**Re: Portsmouth Regional Hospital – Ambulance Bay and Canopy  
Project Narrative  
Portsmouth, NH**

Below are our responses to the Conservation Commission's approval conditions from a meeting held on January 14<sup>th</sup>, 2026:

# Findings of Fact | Wetland Conditional Use Permit

Application #: LU-25-180

WETLAND BOUNDARY  
MARKER PLAN

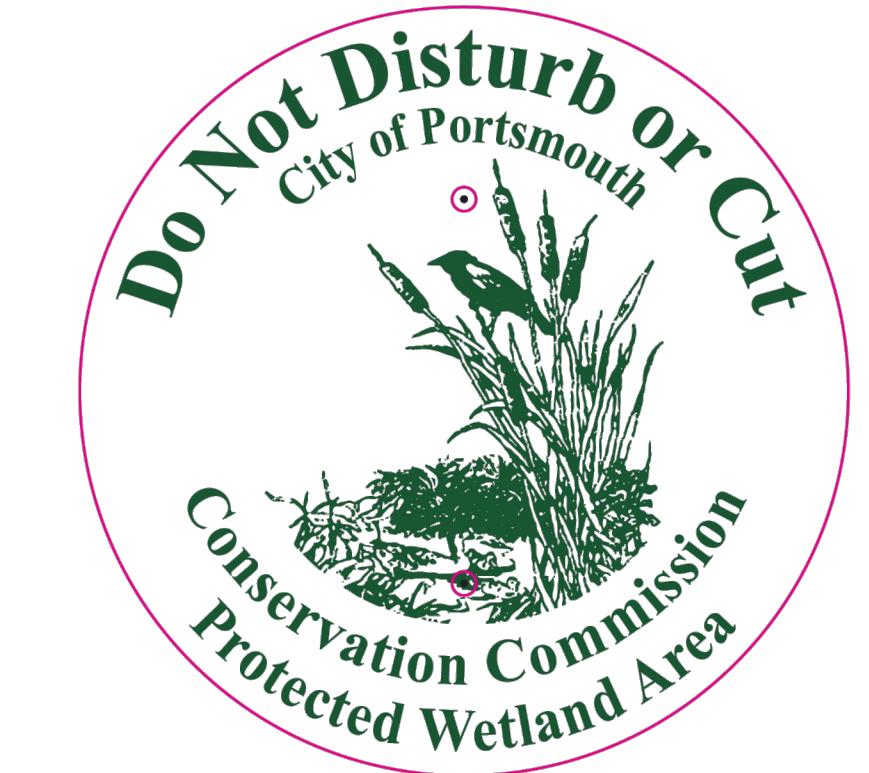
3. *Applicant shall show on plans and install permanently prior to the start of construction, wetland boundary markers every fifty feet along the edge of the swale from the box culvert south down to the intersection of Borthwick Avenue.* **CDG Response: Please refer to the attached drawing sheet C3.1 "Wetland Boundary Marker Plan" that depicts the proposed locations of the requested wetland boundary markers.**

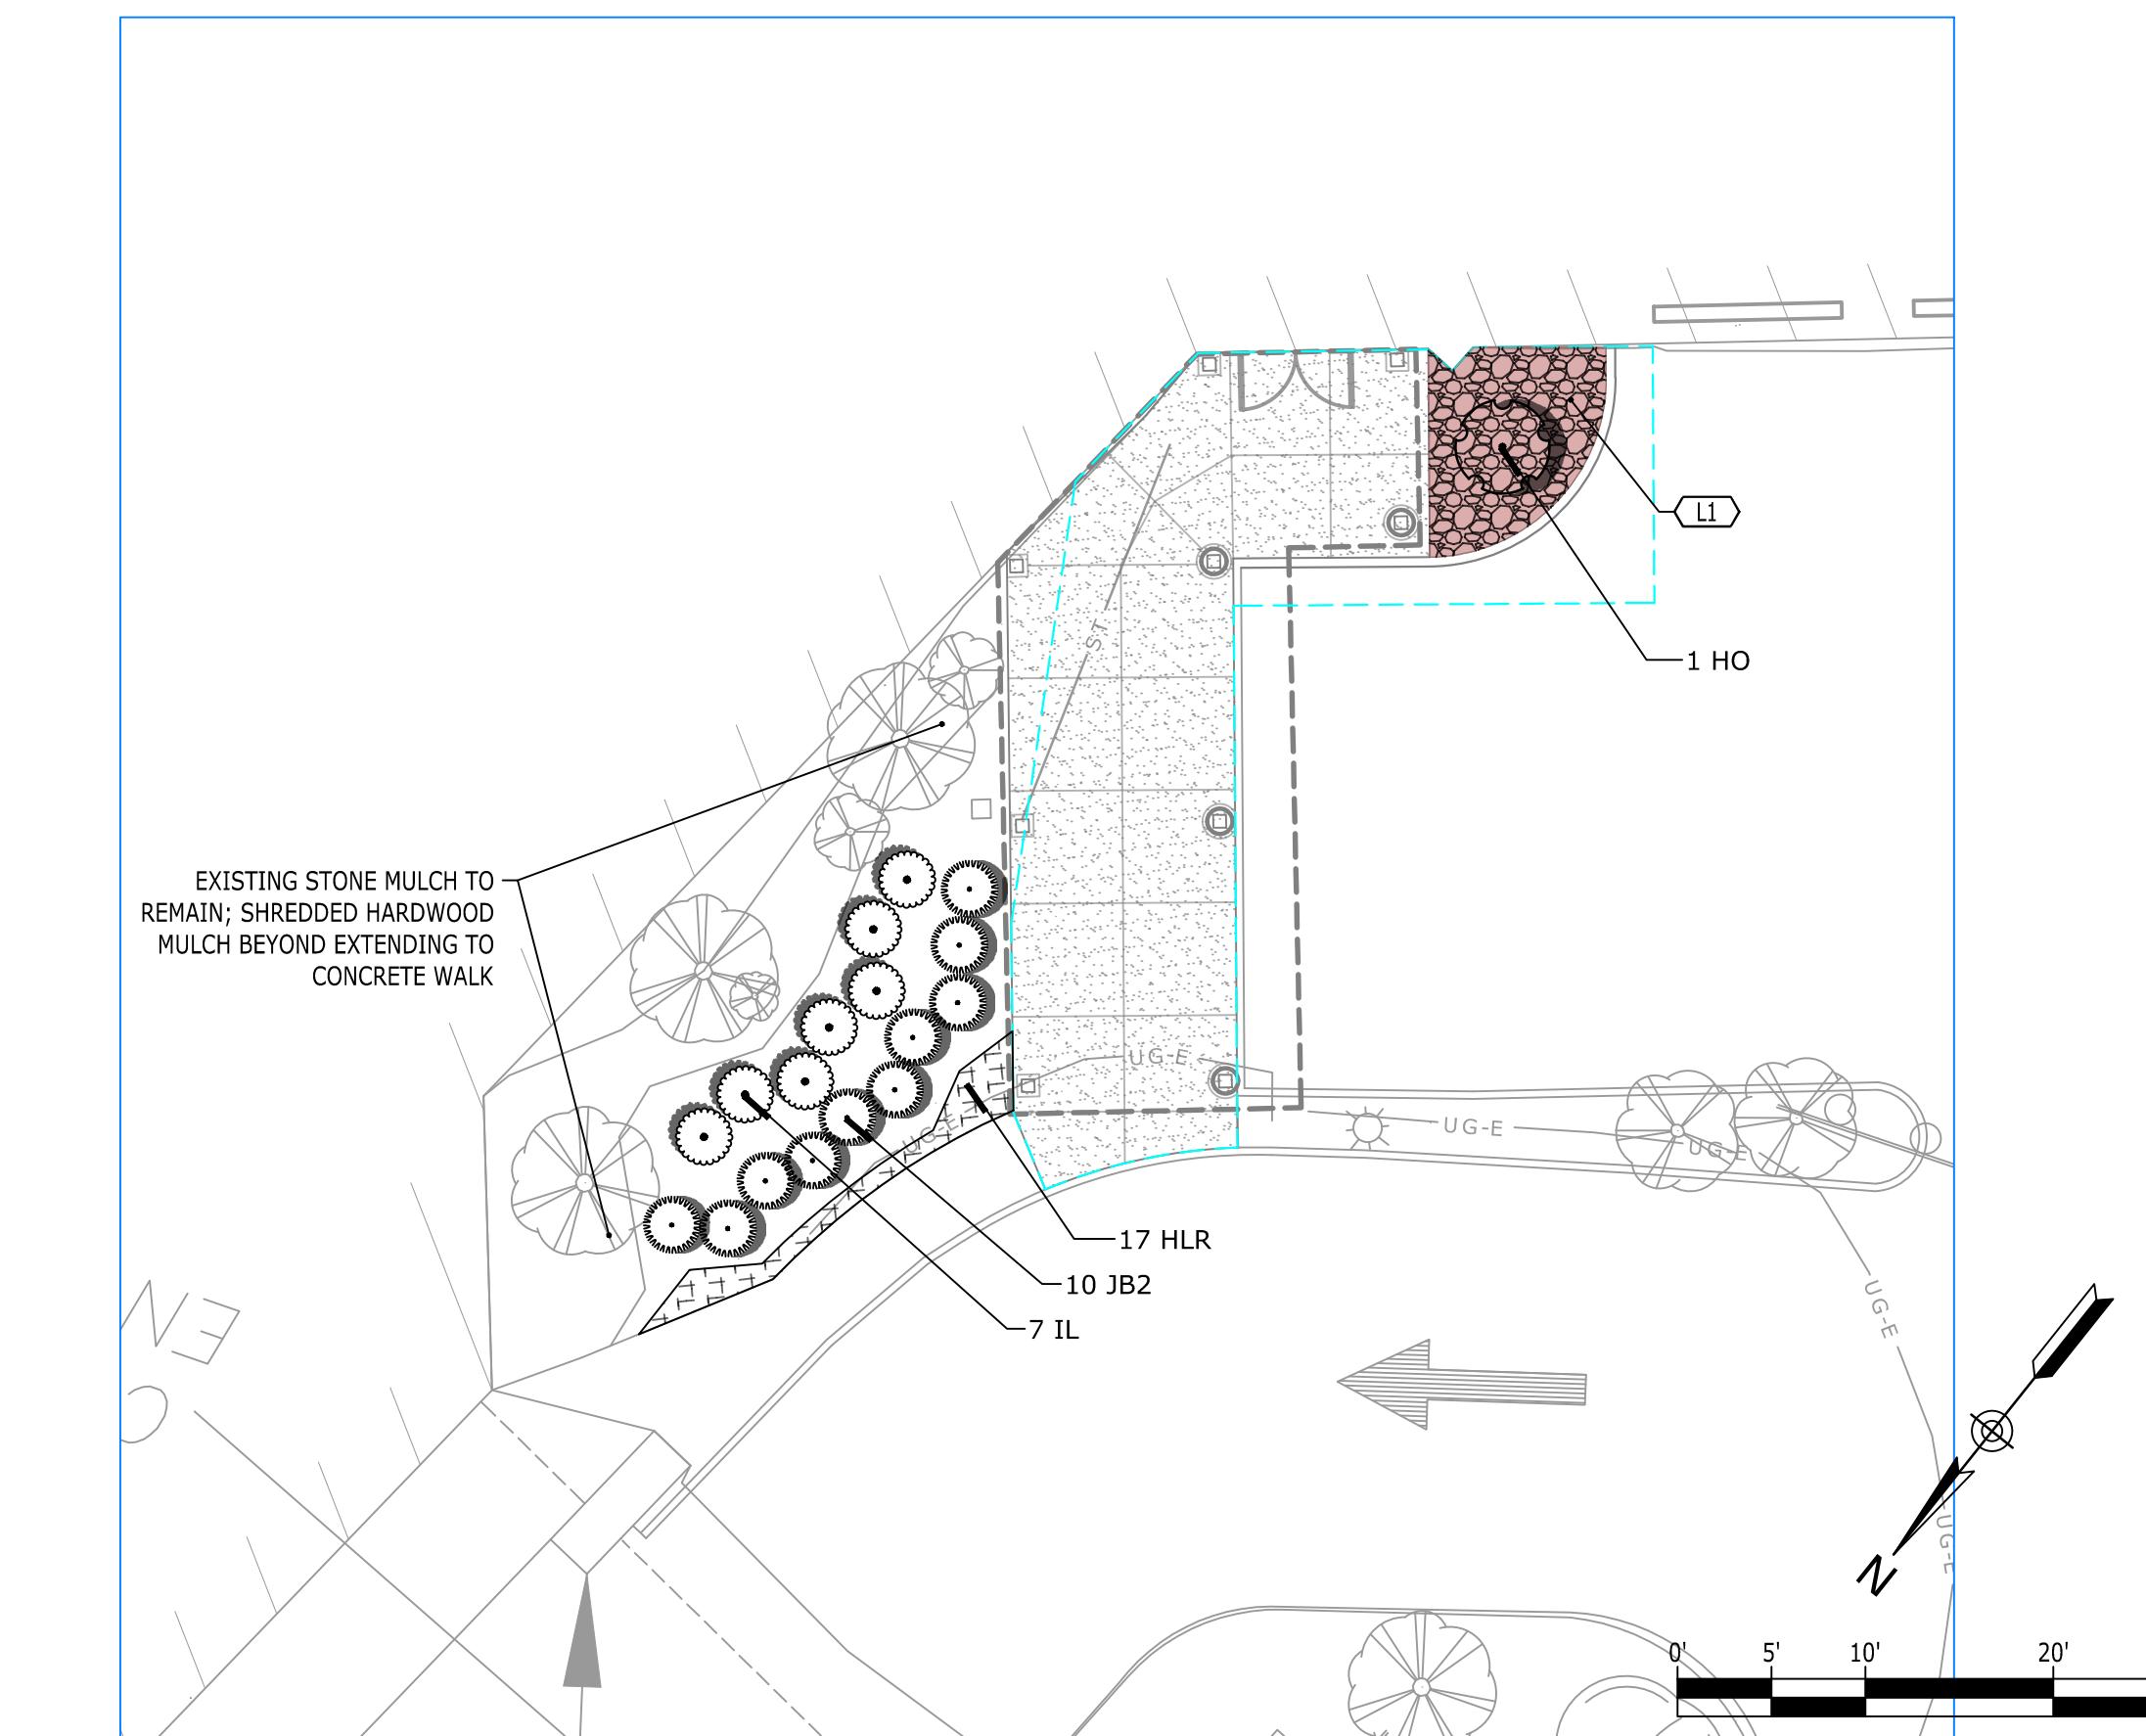
1. *Applicant shall provide a planting plan prior to submission to the Planning Board for the work site which should include new plantings for the river rock area noted on the plan, the area between the new sidewalk extension and existing building, and a portion of the top of the swale bank that stretches the length of the ambulance garage to the lawn south of the helipad.* **CDG Response:** **Please refer to the added drawing sheets L1.0 and L2.0 for proposed landscaping located in the river rock area, and the area between new sidewalk extension and existing building.**

**For the portion of the top of the swale bank, per Gove Environmental Services, Inc.: given the current state of the wetland and the buffer is the natural established condition I think this area is already in a natural state to the extent feasible. The option and potential for supplemental plantings within this limited area were considered; however, given the existing conditions of the wetland and buffer including the dense and established Phragmites population, the location is not viable for plantings that would reasonably result in long-term success. While limited plantings could theoretically provide some degree of buffer protection, it is highly unlikely that any planting effort in this constrained area would result in a noticeable or measurable benefit to the existing functions and values currently provided by the established wetland and its buffer.**
